10. COA-071516-2020

2100 East Broad Street

Commission of
Architectural Review

STAFF REPORT

Figure 1. 2100 East Broad Street, west elevation

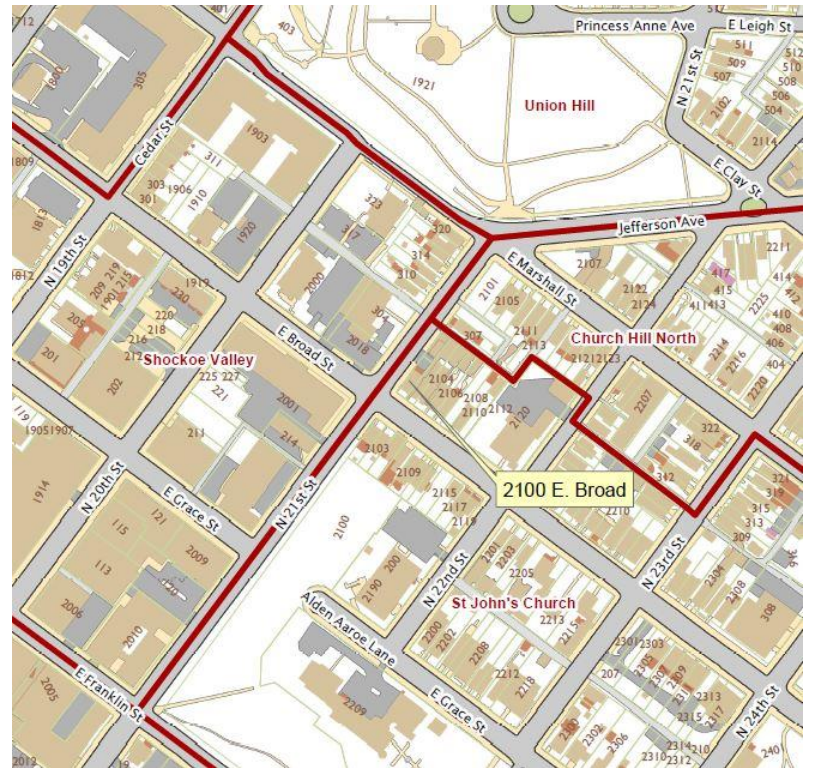
- Staff recommends denial of fiber cement siding on the west elevation and recommends the siding be replaced in-kind with new wood.

The Guidelines clearly state that fiber cement siding is not appropriate for elevations highly visible from the public right of way. Staff recommends denial of fiber cement siding on the highly visible west elevation and recommends the siding be replaced in-kind with new wood.
